Downtown West

Design Standards
and Guidelines
Errata

May 07, 2021

ERRATA

FIGURE 5.7: Architectural requirement summary

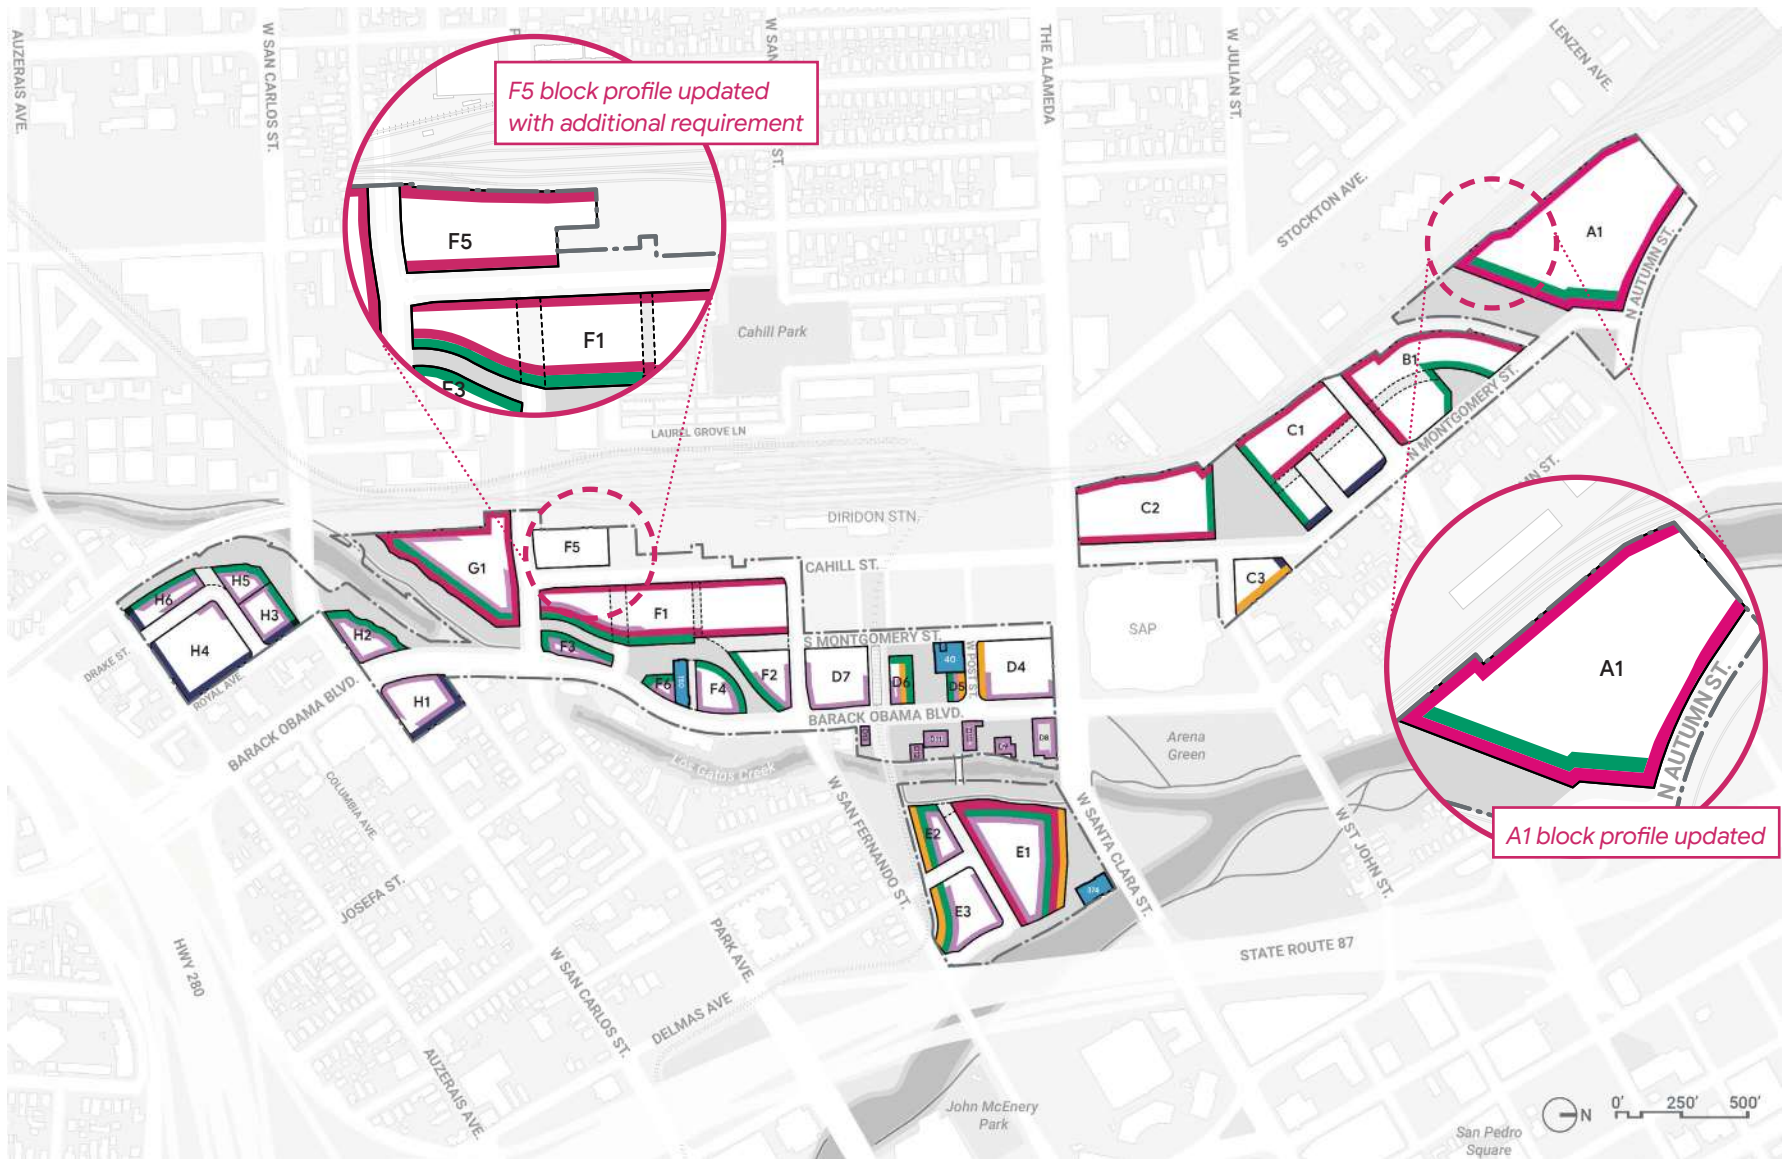
ER_14	170	Buildings	Figure 5.7	Addition of long facade demarcation on F5 east (secondary) and F5 west (primary).
ER_15	171	Buildings	Table 5.1	Addition of long facade demarcation on F5
ER_16	173	Buildings	Figure 5.9	Site boundary changes at F5 and A1
ER_17	176	Buildings	S5.5.7	<ul style="list-style-type: none"> • The existing structure at block D13 shall be replaced by the relocated 35 South Autumn Street (Barack Obama Boulevard) main structure (see S5.15.3). The structure from 35 South Autumn Street shall be relocated within the building footprint of 74 South Autumn (Barack Obama Boulevard) and outside of the 50-foot Los Gatos Creek Riparian Setback. • If the property owner elects to demolish any building on blocks D9 or D12, D12, or D13, the property owner is permitted to replace the demolished built area in a new building elsewhere in Creekside Walk. Replacement structures for blocks D9 or D12, D12, and D13 shall not encroach into the 50-foot Los Gatos Creek Riparian Setback. Individual replacement structures shall be permitted to exceed the gross square footage of the existing structure in accordance with the square footage limits of additions described below. Replacement structures are subject to applicable standards in Sections 5.6, 5.7, 5.8, and 5.13.”

FIGURE 5.30: Primary long facade and secondary long facade locations

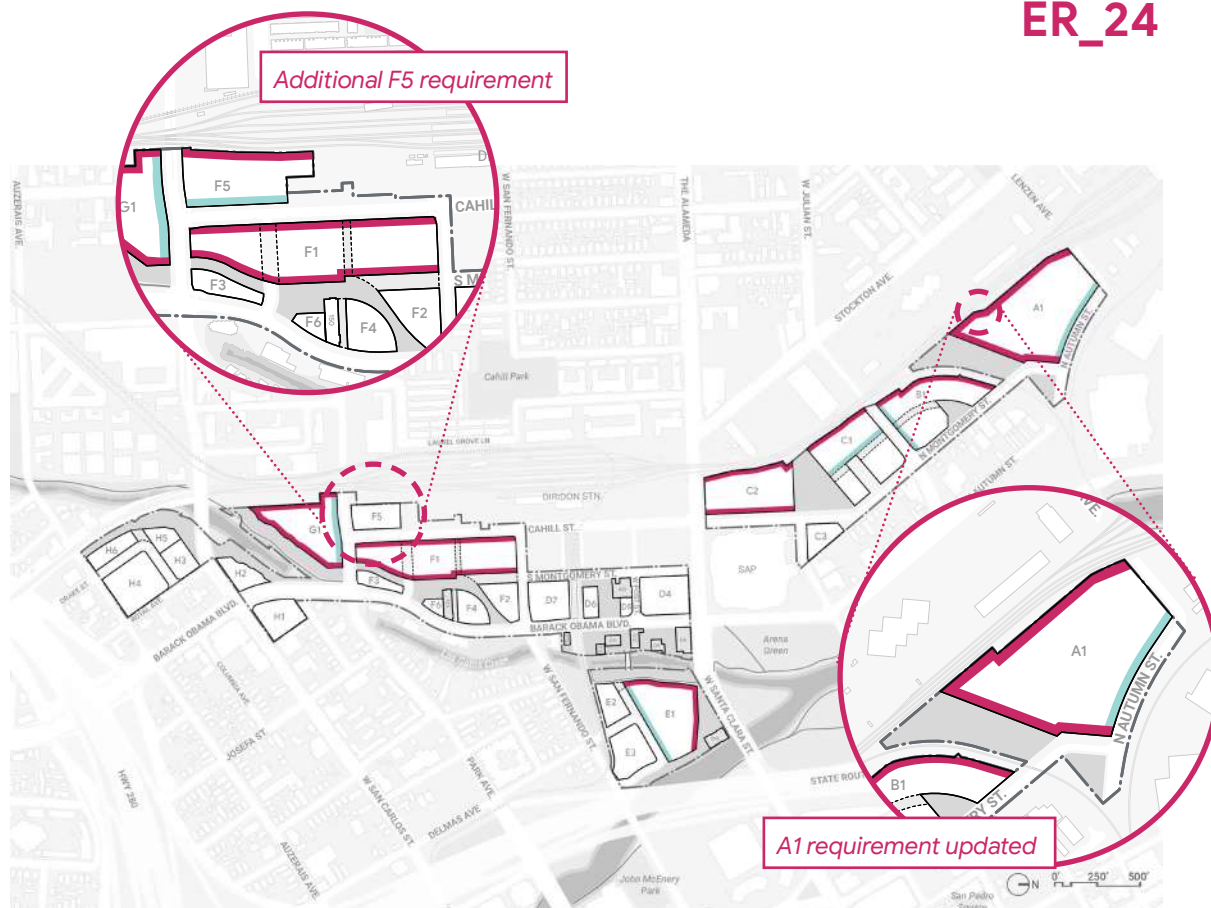
ER_24	202	Buildings	Figure 5.30	Addition of long facade demarcation on F5
ER_25	217	Buildings	S5.15.3	“The main structure of 35 South Autumn Street (Barack Obama Boulevard) — a single family home dating from 1880 located along the west side of Barack Obama Boulevard — shall be relocated to block D13 as a replacement structure pursuant to S5.5.7. within the current building footprint of 74 South Autumn (Barack Obama Boulevard) and outside of the 50-foot Los Gatos Creek Riparian Setback, pending structural feasibility. The relocation of 35 South Autumn (Barack Obama Boulevard) shall be permitted as a replacement of existing structure, a pavilion structure, or a permanent structure (see Section 4.25) within Creekside Walk. The structure shall not be relocated within the 50-foot Los Gatos Creek Riparian Setback. Modification to 35 South Autumn Street (Barack Obama Boulevard), a Structure of Merit, shall not be required to comply with the Secretary of the Interior’s standards.”

FIGURE 6.53: Conceptual off-street parking garages

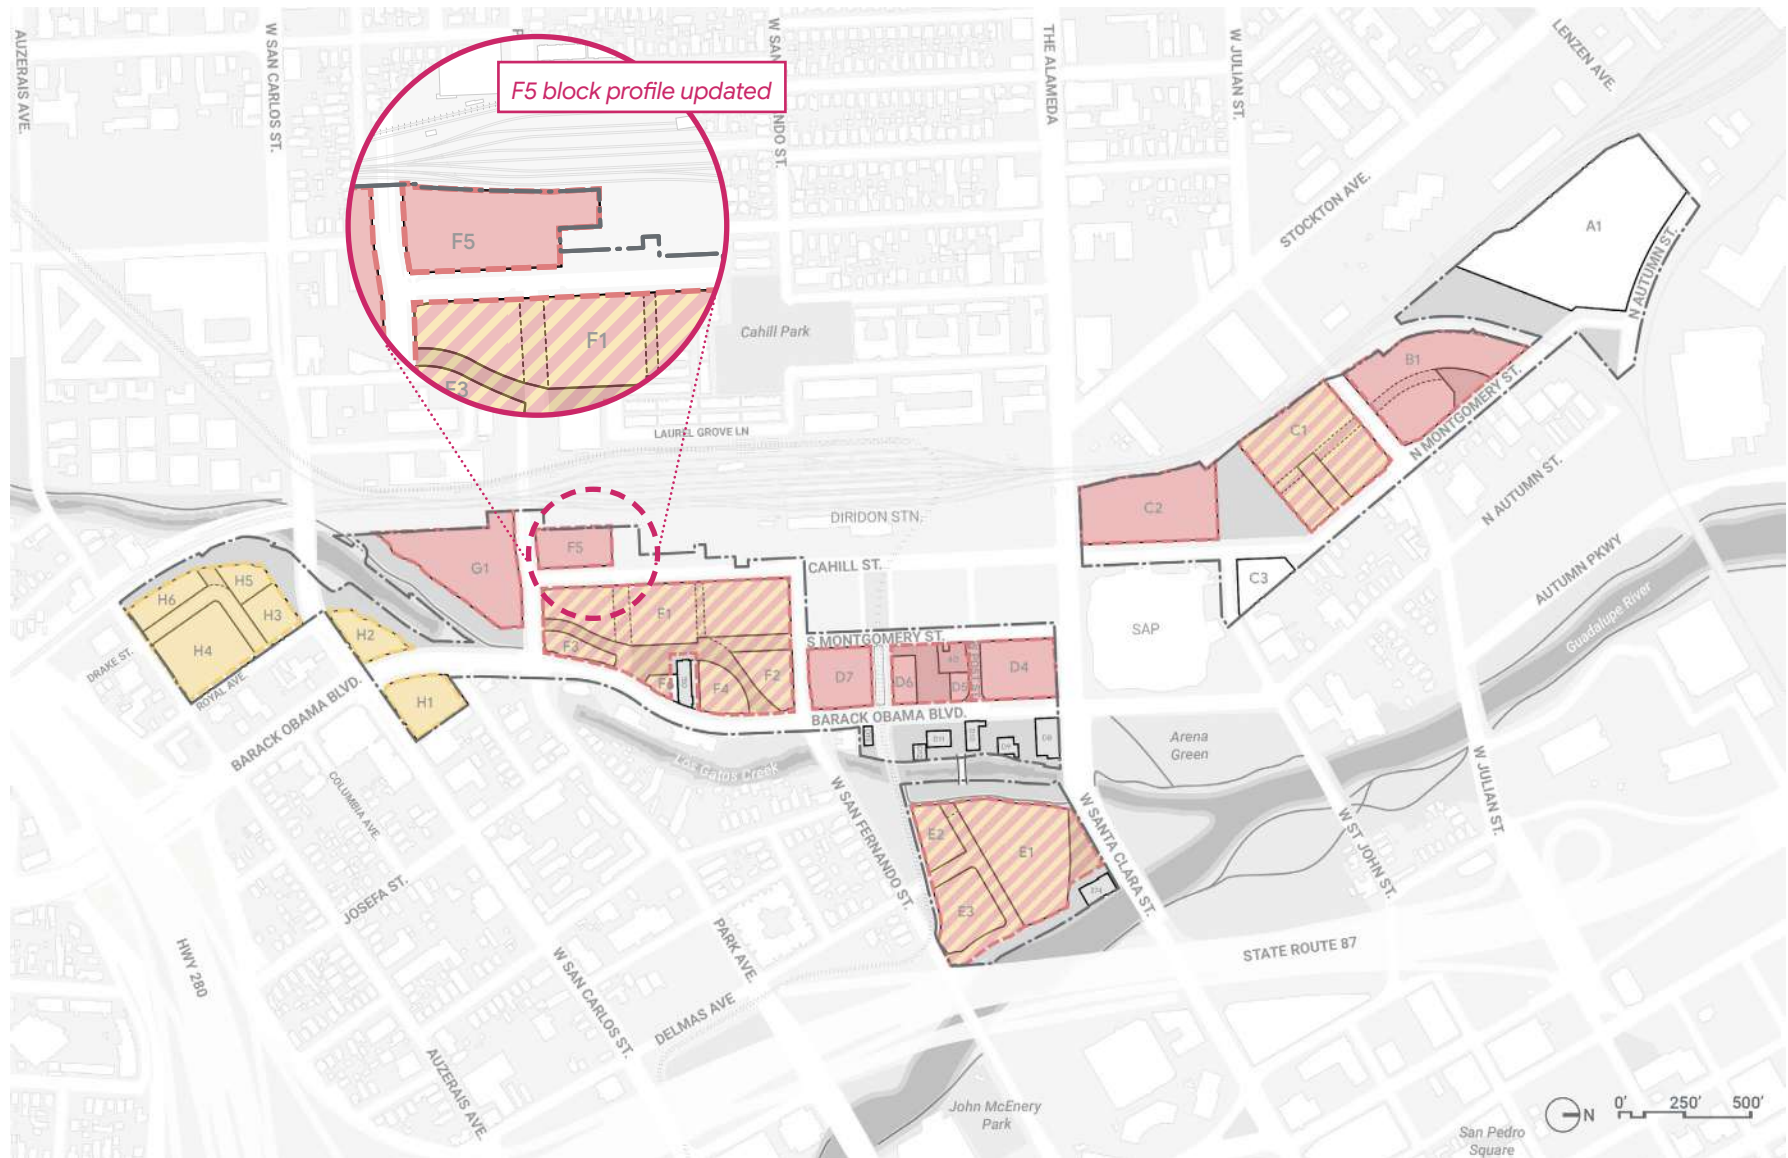
ER_28d	297	Mobility	Figure 6.53	Site boundary changes at F5 and A1
ER_29a	298	Mobility	S6.17.1	“Prohibited curb cut locations. Curb cuts shall be prohibited in the locations identified in Figure 6.54. Additionally, on-street loading and curb cuts for vehicular access to buildings shall be prohibited on open space, except as otherwise allowed by S6.17.3 and S6.17.7 . Temporary loading and service access for events shall be exempt from this standard. Additional curb cuts shall be permitted at the discretion of the City. [DDG Standard 3.3.2.b, Standard 3.5.2.a, Standard 3.5.3.b, Guideline 3.3.2.f — superseded]”
ER_29b	298	Mobility	S6.17.7 (New standard)	“West Santa Clara Street block E1 garage access. Full vehicular ingress and, at a minimum, partial vehicular egress shall be provided between West Santa Clara Street and the below grade parking garage under block E1. Curb cut and ramp design shall be coordinated with the open space design of Los Gatos Creek East (Section 4.17) and Gateway to San José (Section 4.18) to minimize the impact on pedestrian experience and safety, while maintaining the view corridor to 374 West Santa Clara Street. Any curb cut and ramp shall remain physically separated by planting, materials, or other design features from the Los Gatos Creek Trail.”

FIGURE 6.54: Prohibited curb cut locations

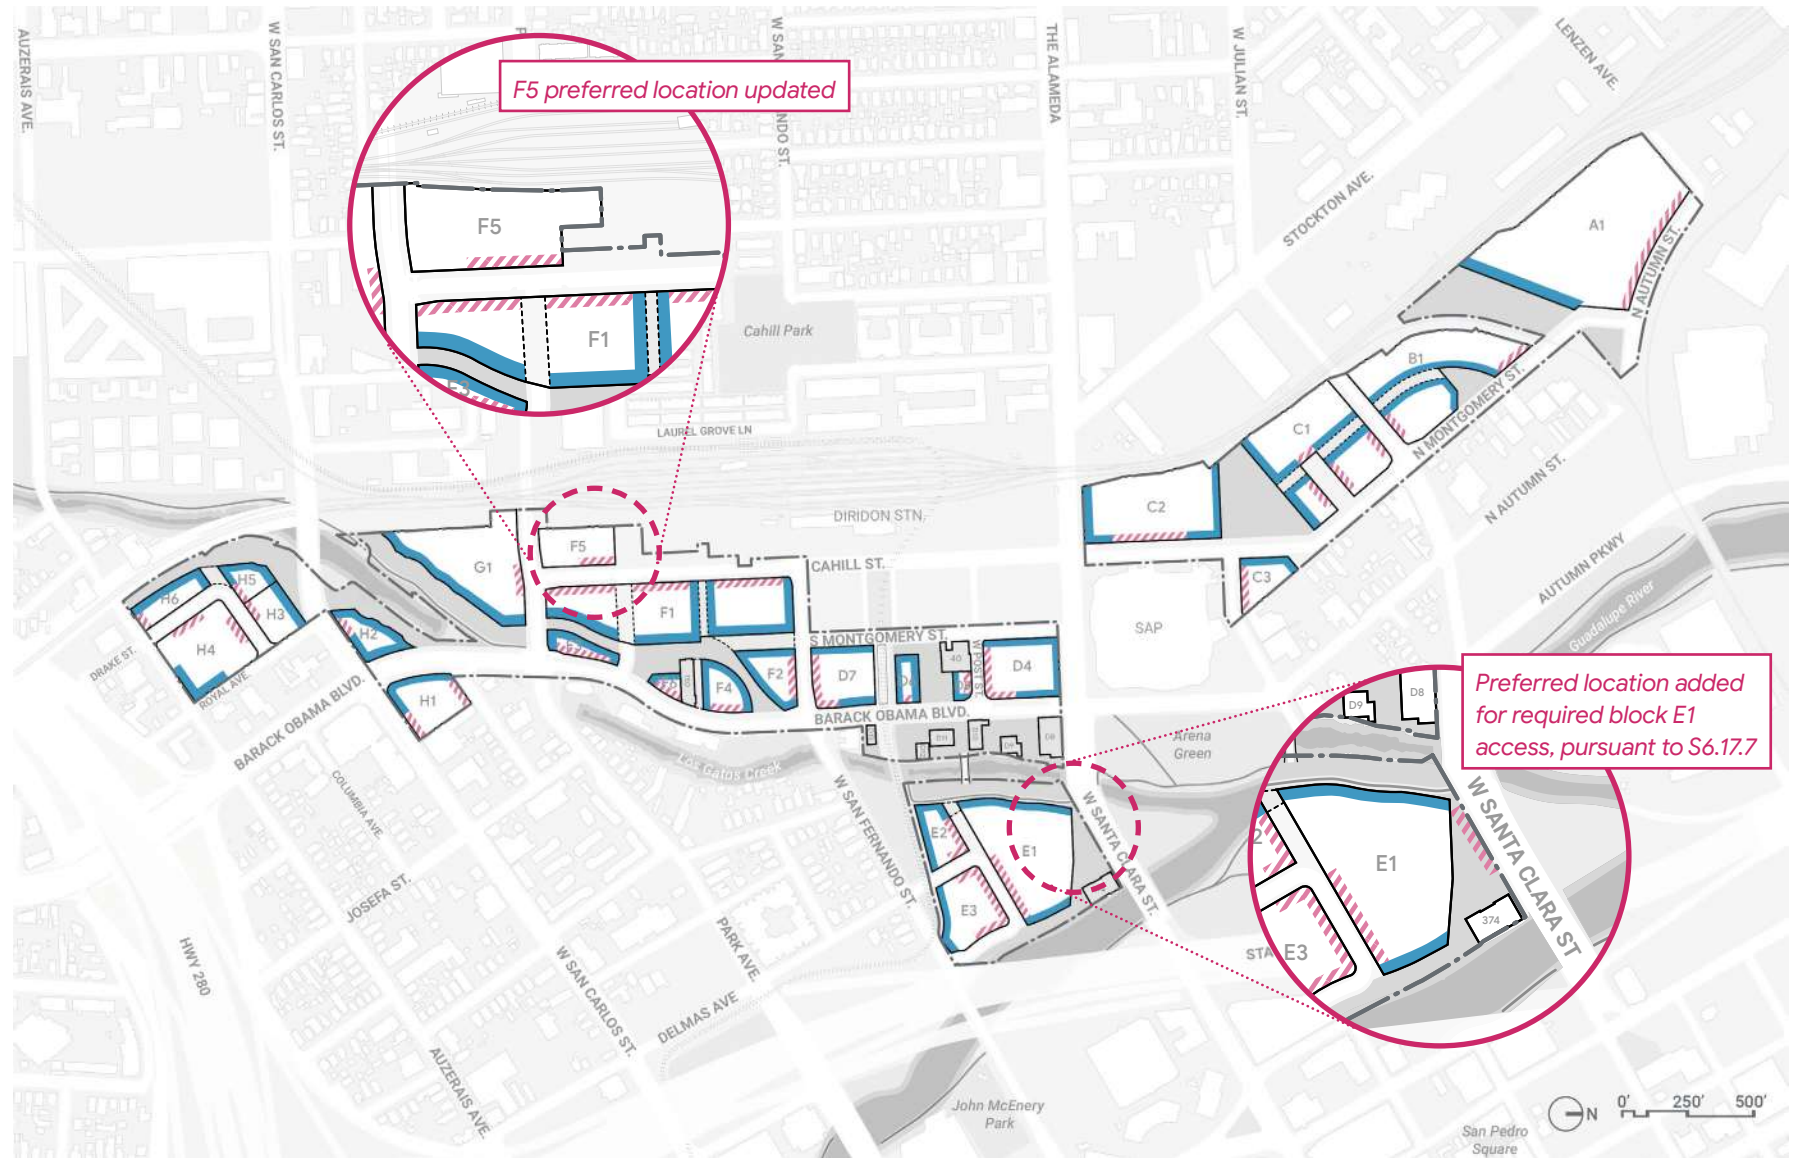
ER_29c	299	Mobility	Figure 6.54	Preferred location added for required block E1 access pursuant to S6.17.7

ER_29c	299	Mobility	Figure 6.54	Site boundary changes at F5 and A1, F5 preferred location updated, preferred location added for required block E1 access, pursuant to S6.17.7
ER_30	307	Lighting and Signage	S7.3.3	“All open space lighting, excluding lighting for art , shall install lighting that has have a color temperature of less than or equal to 2,700 2700 kelvins. Lighting requirements for art adjacent to a riparian corridor shall follow S7.4.7.”

S6.17.7 West Santa Clara Street block E1 garage access. Full vehicular ingress and, at a minimum, partial vehicular egress shall be provided between West Santa Clara Street and the below grade parking garage under block E1. Curb cut and ramp design shall be coordinated with the open space design of Los Gatos Creek East (Section 4.17) and Gateway to San José (Section 4.18) to minimize the impact on pedestrian experience and safety, while maintaining the view corridor to 374 West Santa Clara Street. Any curb cut and ramp shall remain physically separated by planting, materials, or other design features from the Los Gatos Creek Trail.
